To: **South Tyneside Council**
From: **Iceni Projects Ltd (Transportation)**
Date: **9th March 2016**
Title: **ST/0955/15/FUL - Former Be Modern Premises, Western Approach, South Shields**

a. Introduction

b. Response to STC Comments

A1. COACH SWEEP PATH ANALYSIS

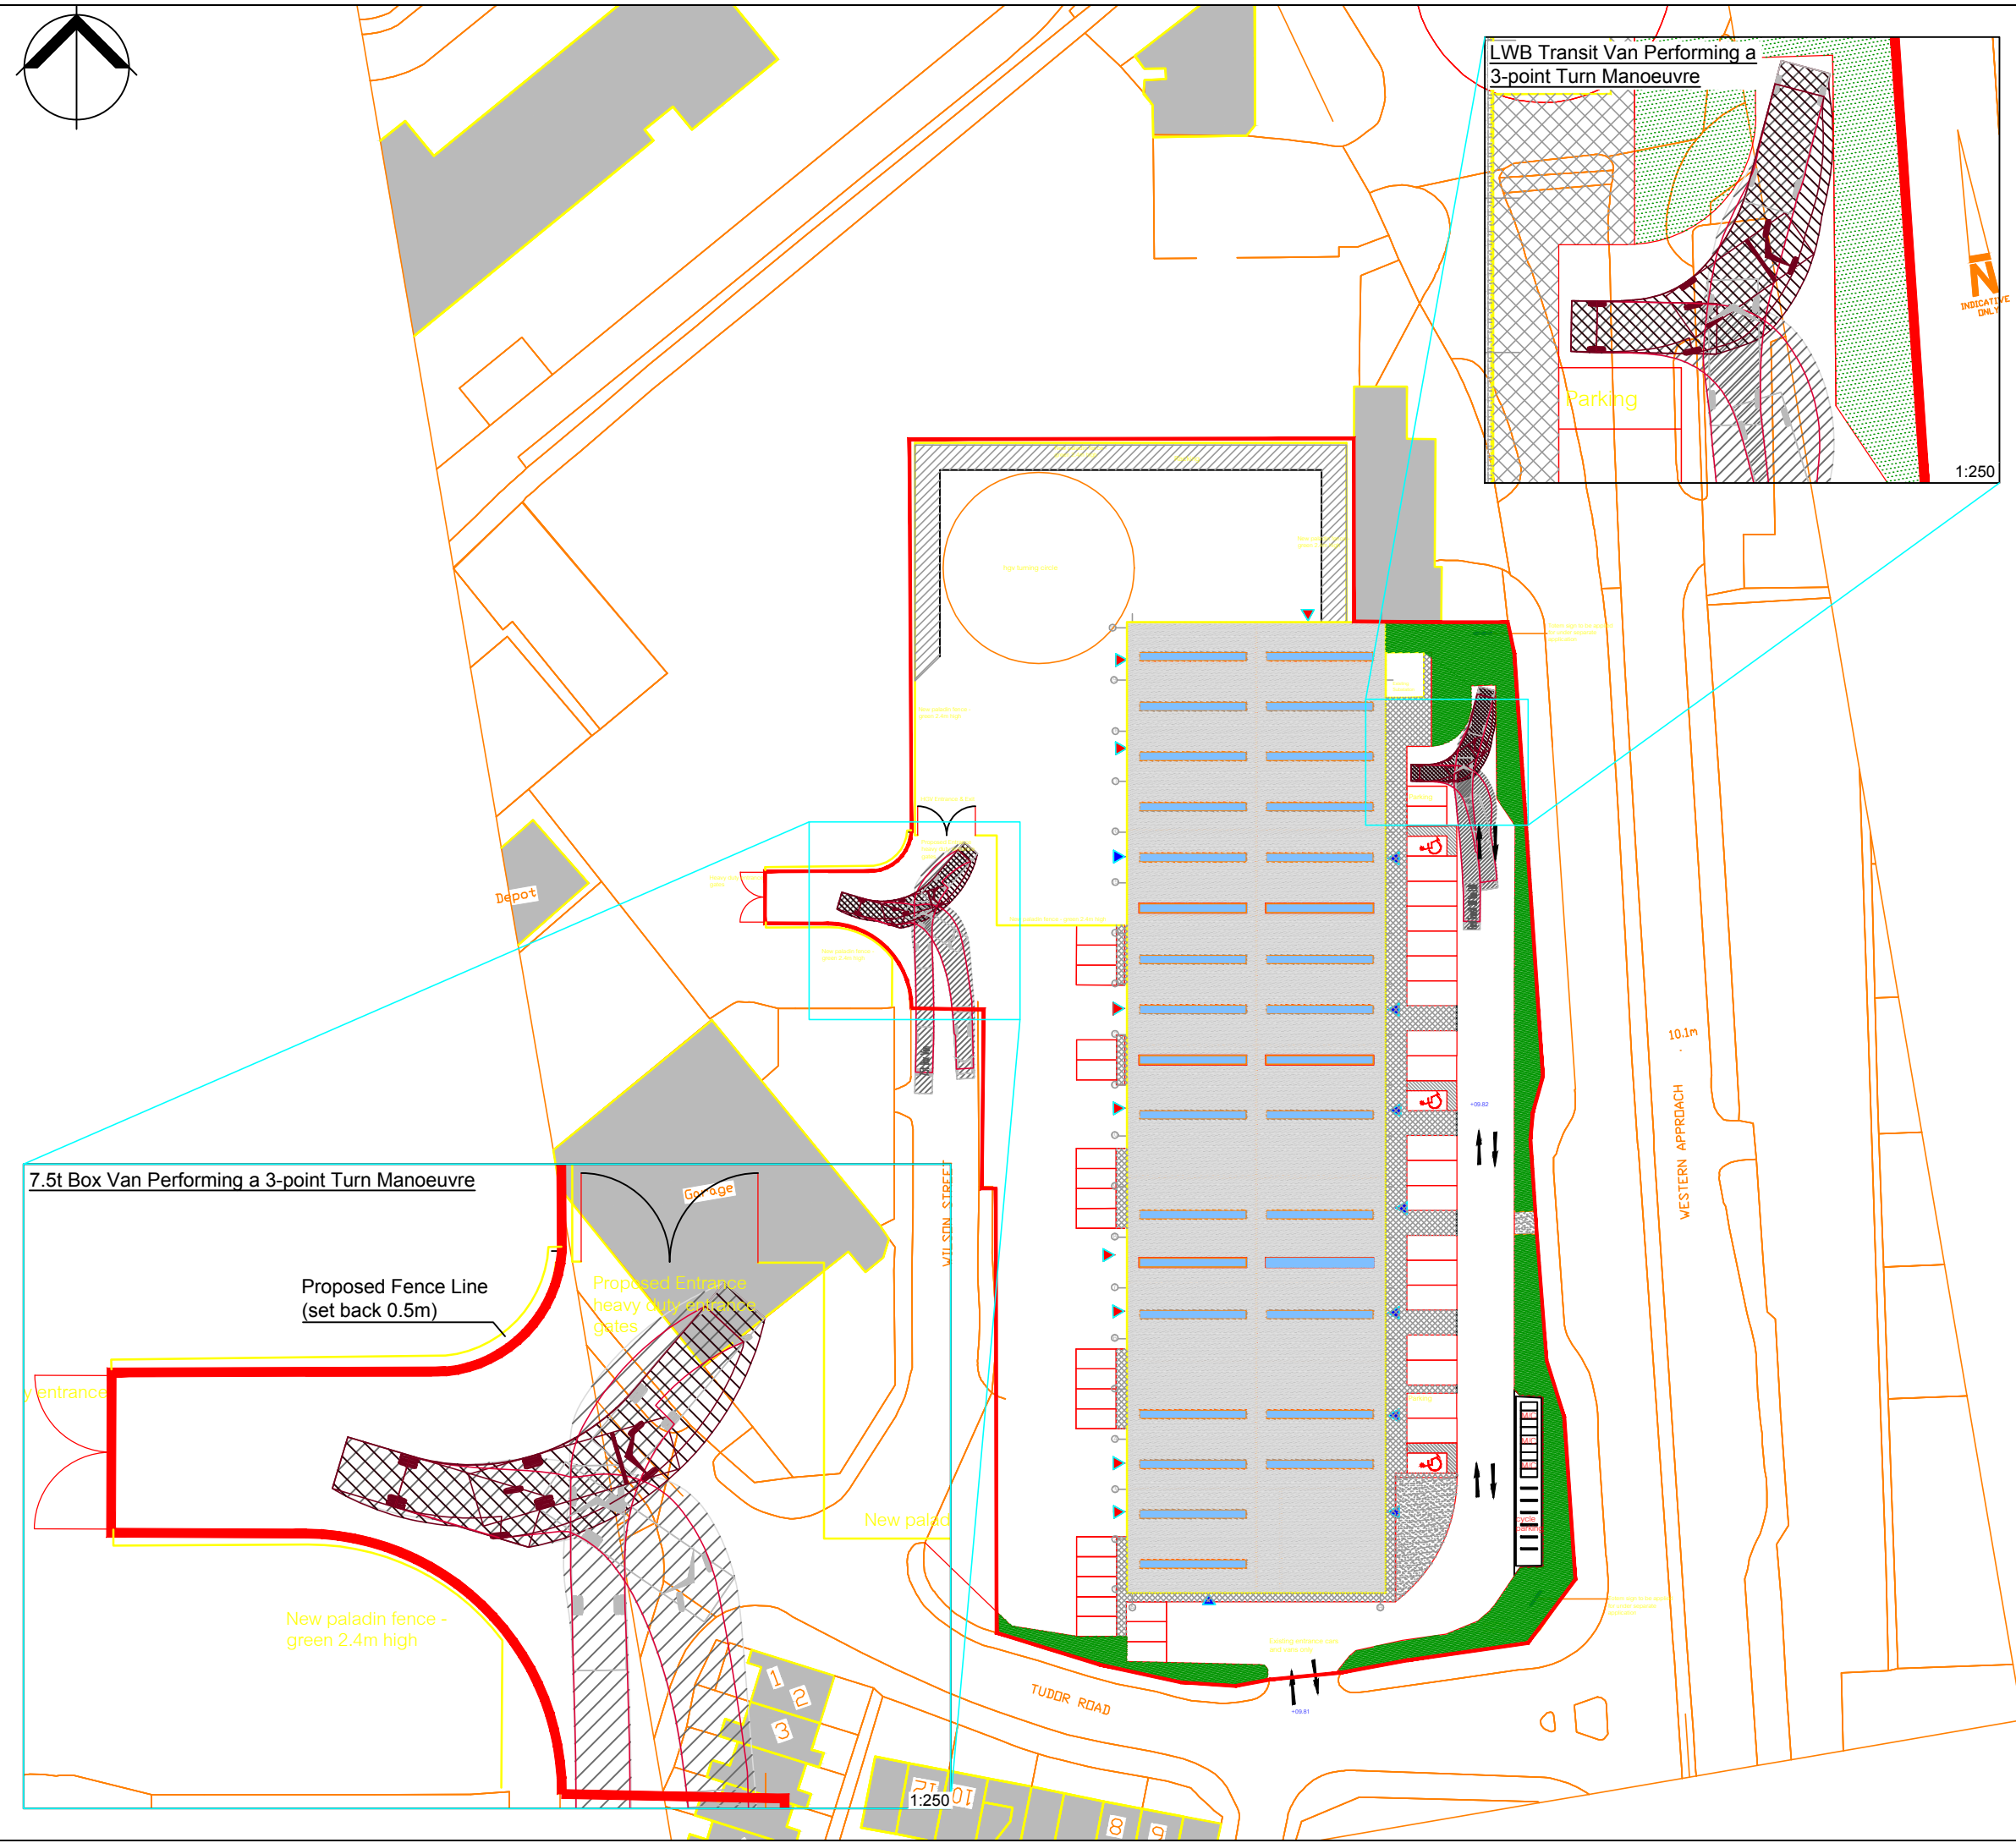
5. *In relation to the manoeuvring of coaches to the adjacent Harkers site, a further vehicle tracking is required for a 12m long coach to demonstrate that a coach can access garages A and B (as referenced on your plans/transport note, - the two garages closest to the Travis Perkins yard) by using the turning head and then reversing into the bays (from the vehicle facing forwards toward the Tudor Road junction).*

11. With regard to the ability for coaches to turn within the turning head to enable them to turn at the end of Wilson Street so they will not need to reverse along the road, a further swept path analysis has been undertaken to ascertain the extent to which the turning head would need to be extended. Drawing 15-T067_15A, included at Appendix A1, shows that by extending the turning head by 8m coaches will be able to turn around without encroaching onto the site enabling them to travel in both directions along Wilson Street in forward gear. This is betterment compared with their existing situation.

32. Harkers Coaches will have better access to the garages as there will be more space to overhang the site when manoeuvring compared with the previous and current situation with the fence around the site. The turning head could be extended to enable them to turn round at the end of Wilson Street, enabling them to travel in forward gear in both directions along the road; this should be considered as betterment.

A2. PALADIN FENCE LOCATION

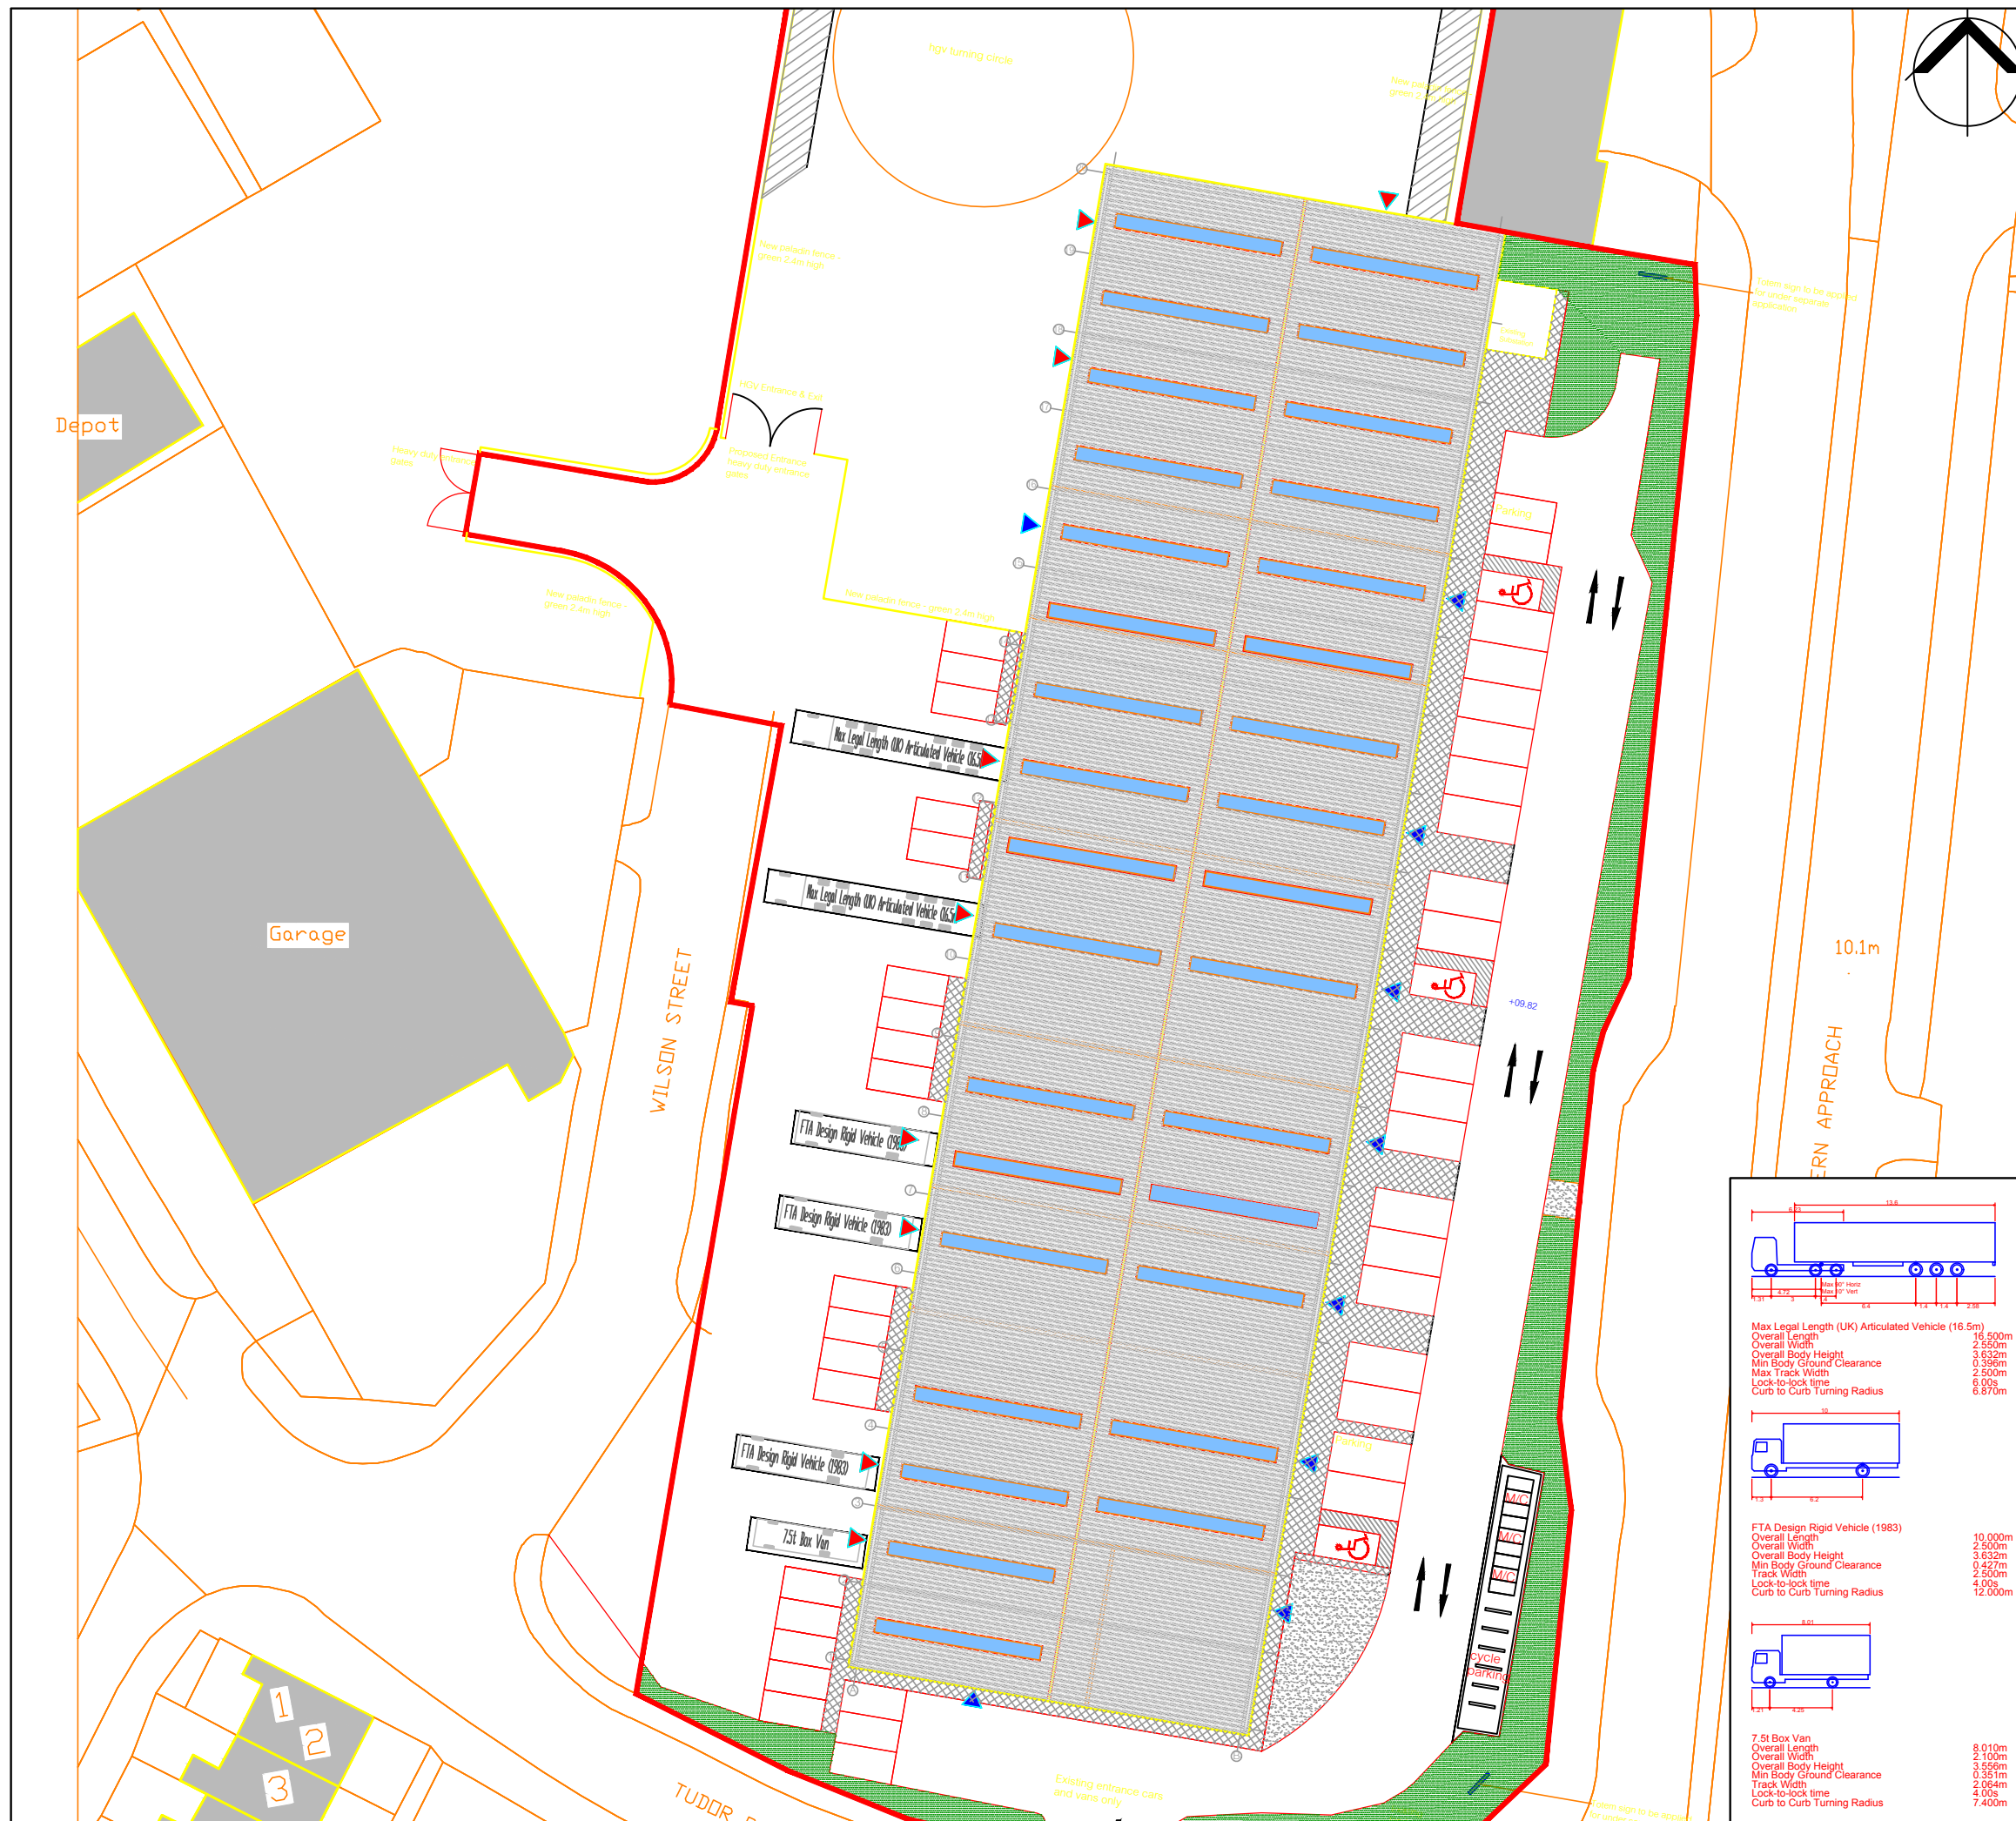
12. *The fence lines to the service yard to Travis Perkins and the paladine fence to the new turning head will need to be set back from the adopted highway by 0.5m. I append an extract from a plan that annotates the changes needed – (although please note this has not been accurately drawn).*
13. Drawing 15-T067_10C, included at Appendix A2, shows the revised fence line as requested.

33. The proposed fence line around the turning head can be offset by 0.5m from the edge of the carriageway.
34. The proposed amended lighting column location could be reconsidered by Balfour Beattie on behalf of STC, but it is considered that this should wait until the detailed design stage.

A3. HGV PARKING

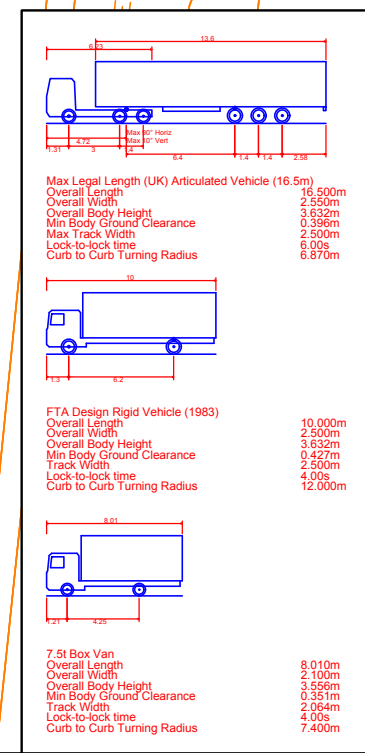
18. *The vehicle tracking still identifies that delivery vehicles (the cab) will overhang onto the adopted highway. We discussed this previously and advised that an overhang would not be acceptable. The service shutters should be recessed to allow the length of vehicle to be accommodated within your site.*
19. Drawing 15-T067_04C, included at Appendix A3, shows that by recessing the loading doors by 0.5m there will be sufficient space for all vehicles to wait off the highway with a 1m buffer from the

back of the carriageway. This is considered sufficient to ensure that service vehicles do not impede vehicles travelling along Wilson Street.
